Groundwater Transfer Review Summary Form

Transfer/PA # T- <u>14343</u>
GW Reviewer <u>Stacey Garrison/Travis Brown</u> Date Review Completed: <u>7/22/2024</u>
Summary of Same Source Review:
$\ \square$ The proposed change in point of appropriation is not within the same aquifer as per OAR 690-380-2110(2).
Summary of Injury Review:
The proposed transfer will result in another, existing water right not receiving previously available
water to which it is legally entitled or result in significant interference with a surface water source as per 690-380-0100(3).
Summary of GW-SW Transfer Similarity Review:
☐ The proposed SW-GW transfer doesn't meet the definition of "similarly" as per OAR 690-380-2130.
This is only a summary. Documentation is attached and should be read thoroughly to understand the

Ground Water Review Form:

Hunt 1999-POA 3/New Greenhouse Well/PROP 482 (at full non-reduced rate)

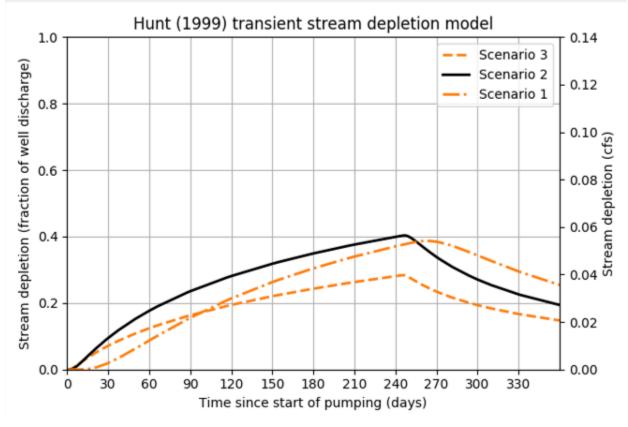
- 7. What conditions or other changes in the application are necessary to address any potential issues identified above: N/A
- 8. Any additional comments: To avoid a Significant Change in Degree of Interference with the North Santiam River, the applicant can remove POA 3/New Greenhouse Well (PROP 482) and POA 4/Well 4 (PROP 483) from the transfer. Alternatively, the pumping rate can be reduced for POA 3/New Greenhouse Well (PROP 482) and POA 4/Well 4 (PROP 483) such that the degree of interference for the months the North Santiam is over-appropriated (August, September, October) is the same as produced by pumping at the maximum rate at the authorized POA that water is being transferred from, POA 2/GR Well 4 (MARI 16008) The reduced rate to achieve the same degree of interference as POA 1/GR Well 1 (MARI 16007) is 0.106 cfs (47.6 gpm) for POA 3/New Greenhouse Well (PROP 482), and 0.104 cfs 46.4 gpm) for POA 4/Well 4 (PROP 483).

The combined pumping rate for all POAs under this transfer for the subject acreage should not exceed the proportional rate of 0.14 cfs. For example, if POA 4 is pumped at the maximum reduced rate of 0.104 cfs, then POA 3 or 5 should not be simultaneously pumped at more than 0.036 cfs.
